A New Fire Station for
Harmonville Fire Company – Plymouth Valley Station

DOCUMENT 00 9001 - ADDENDUM NUMBER 2 – 3/28/25

SHEET TITLE

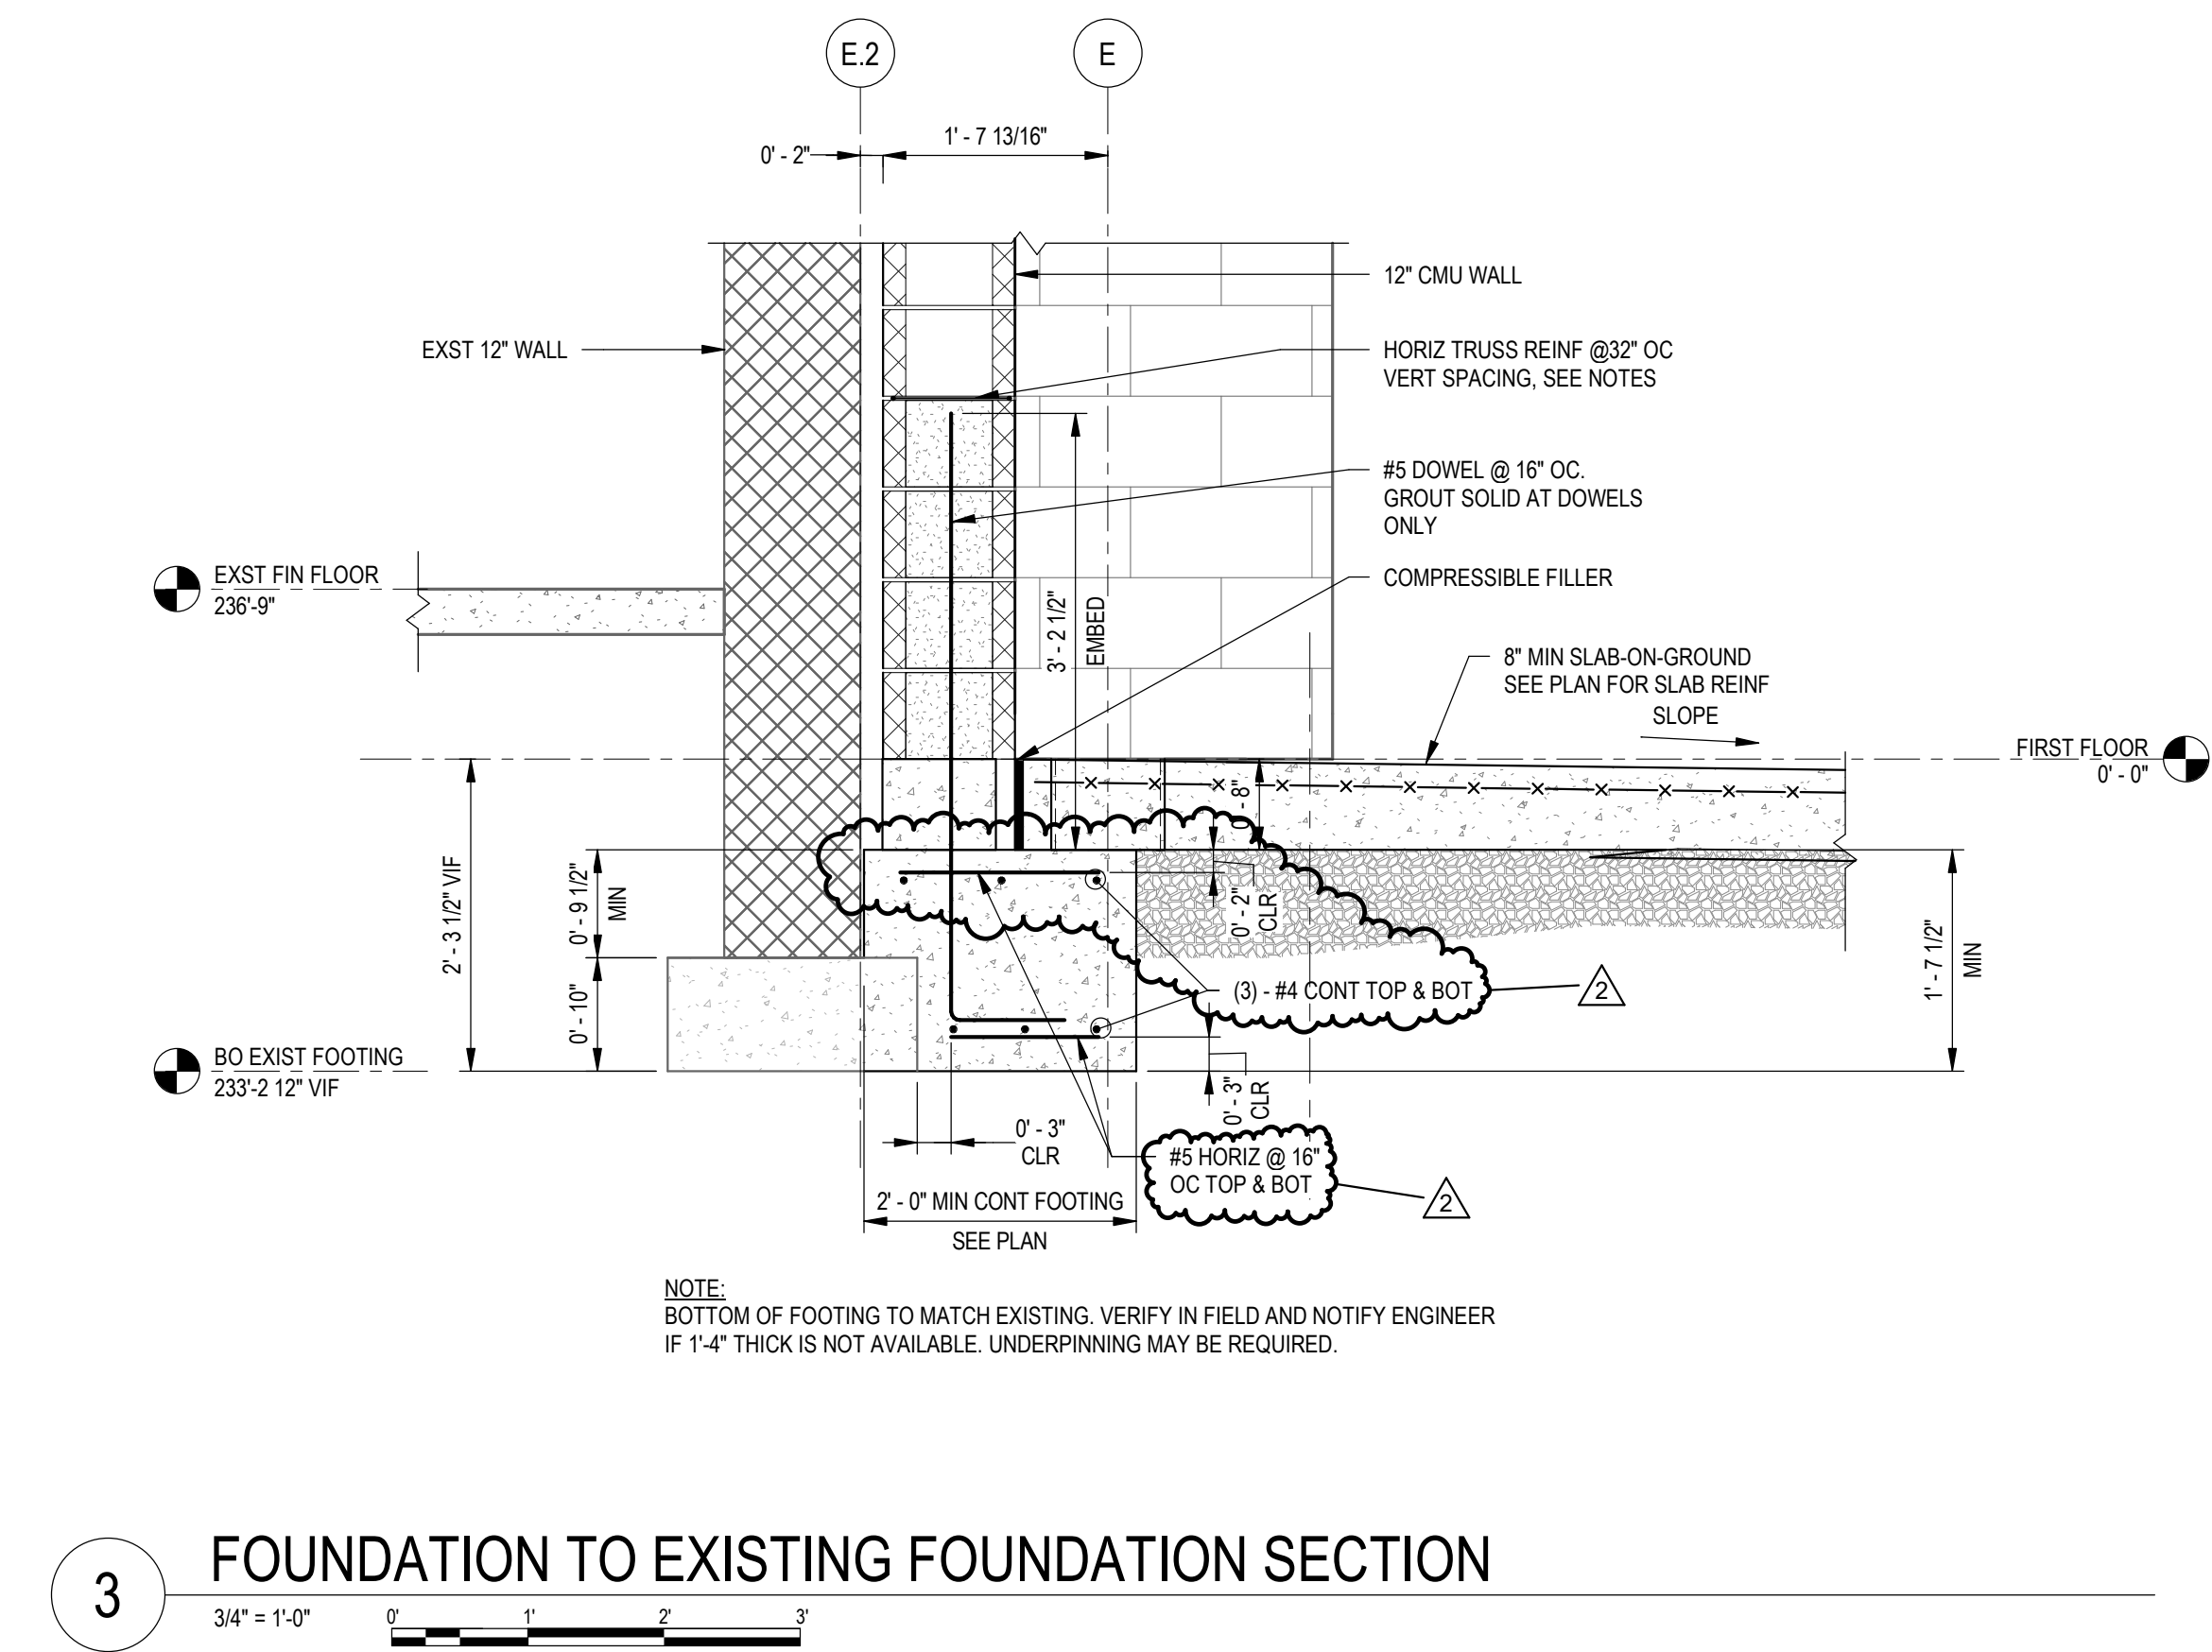
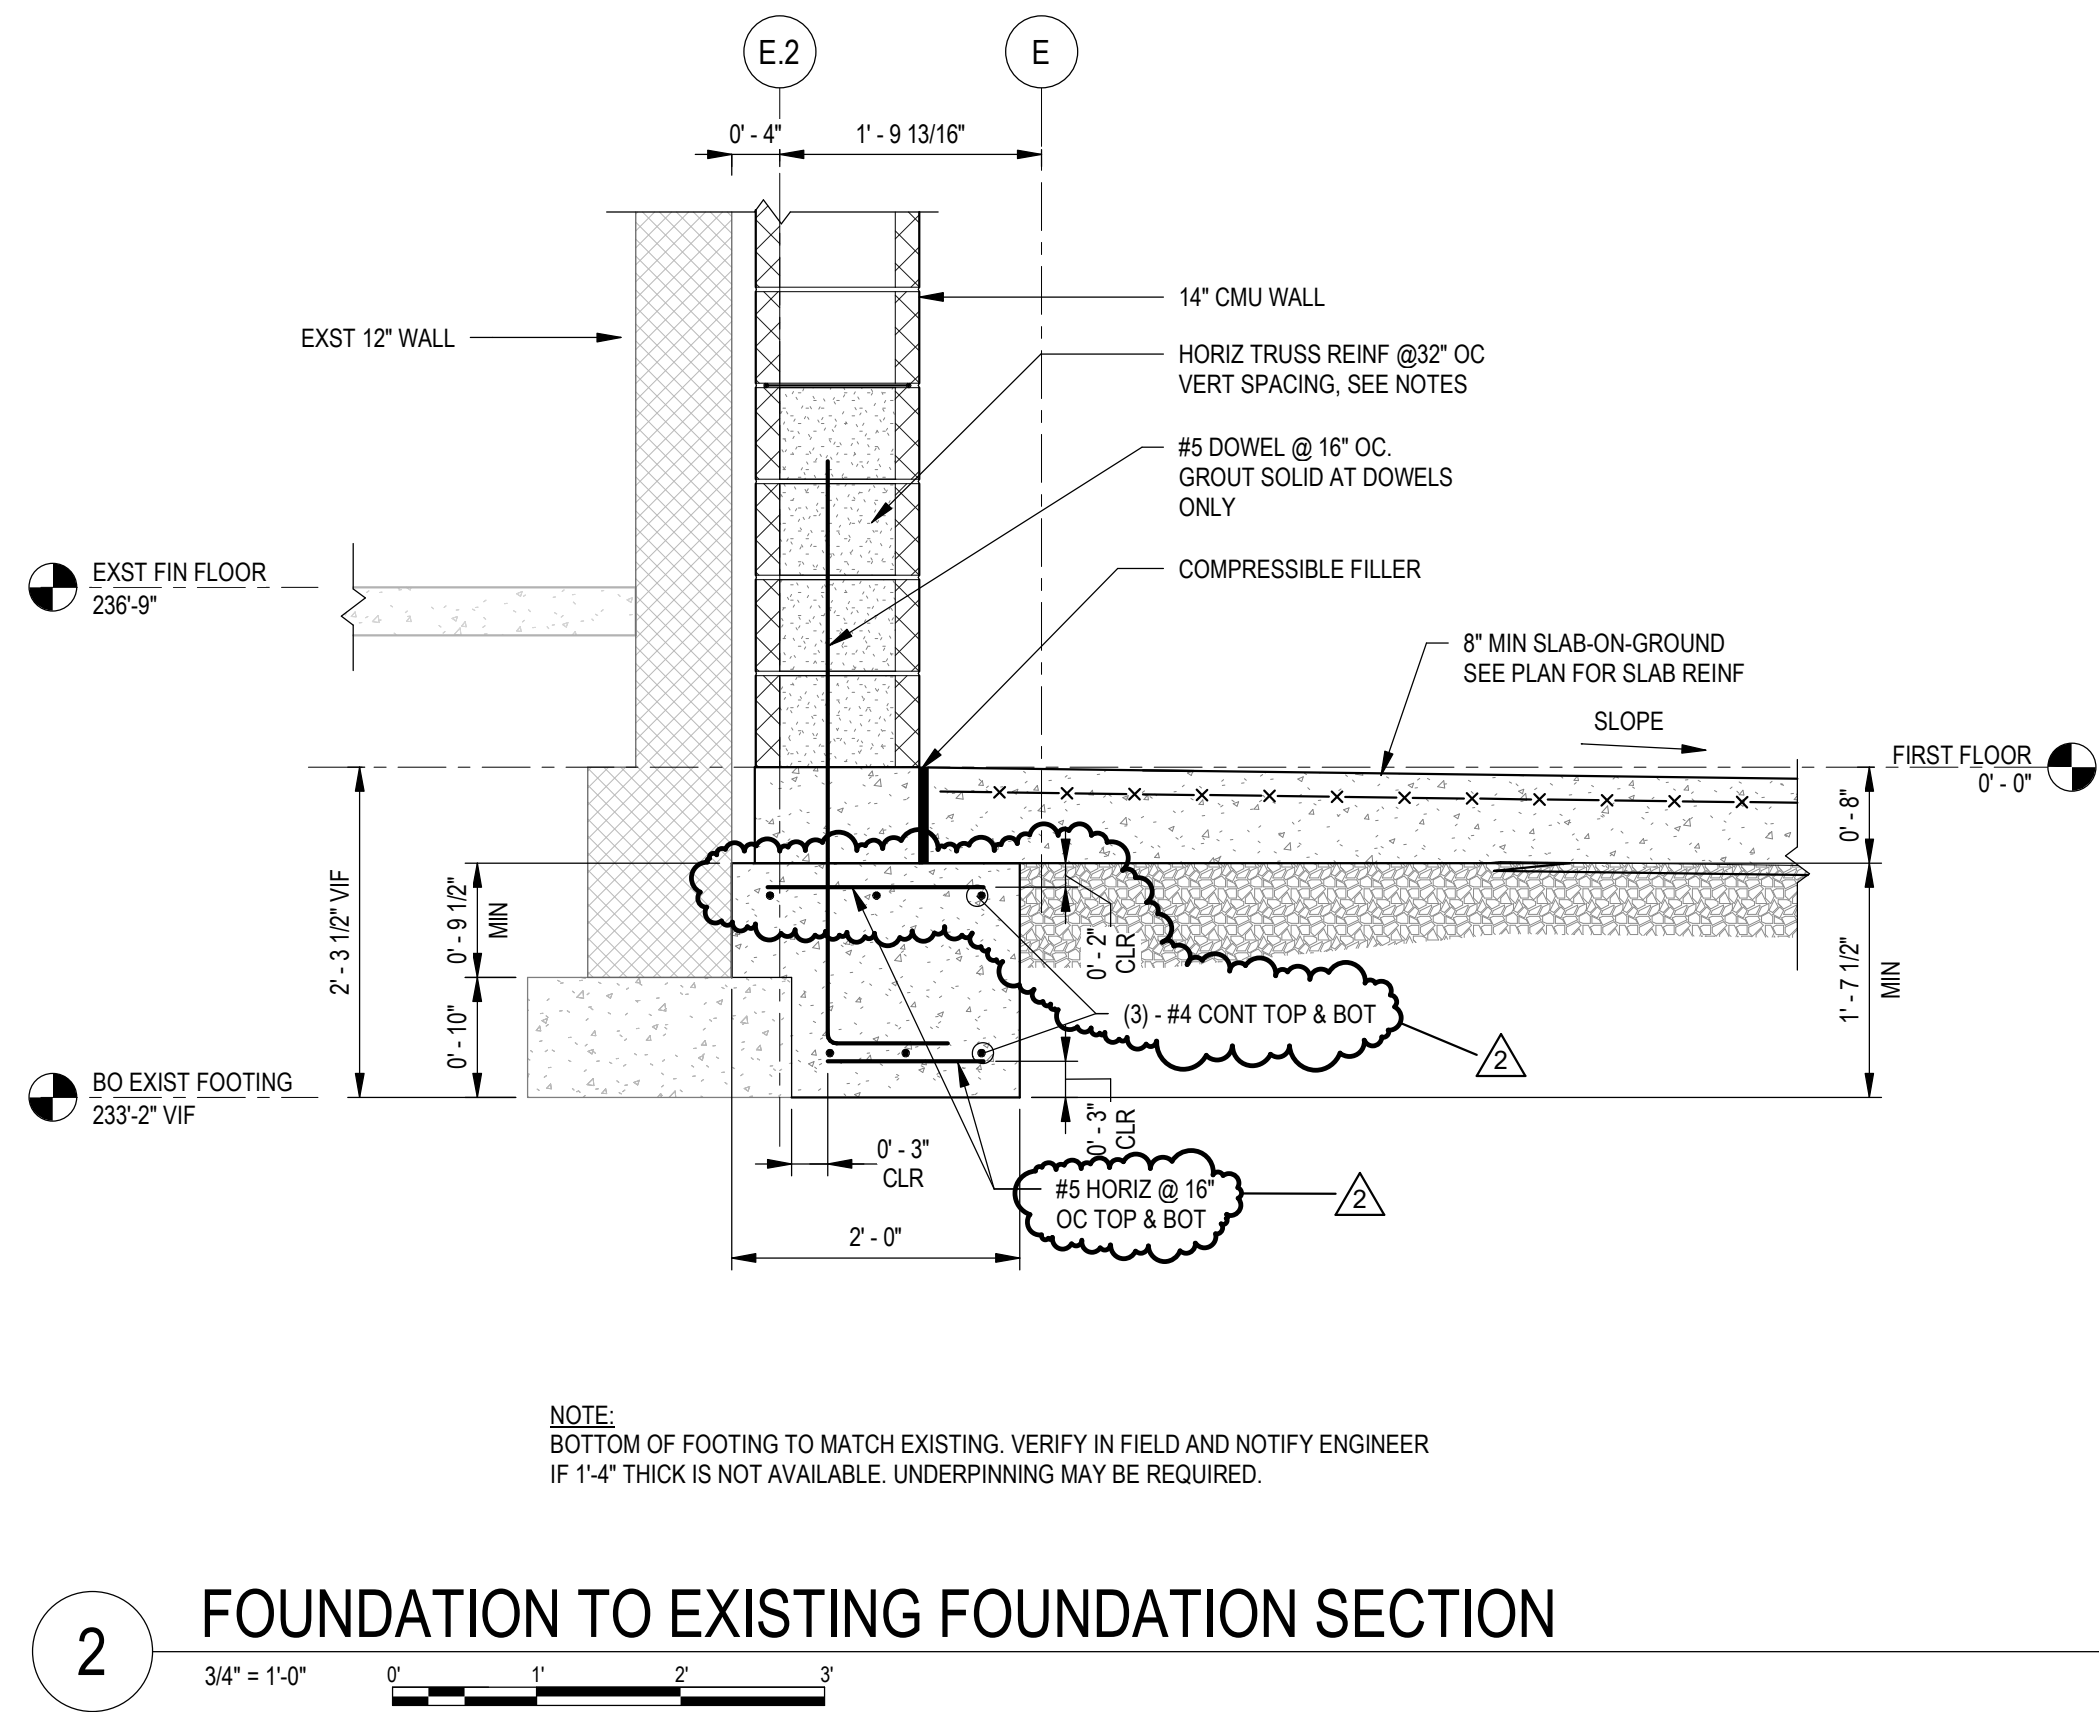
- 9001.20 Drawing sheet S3.01 foundation details have been updated to coordinate with the drawings.
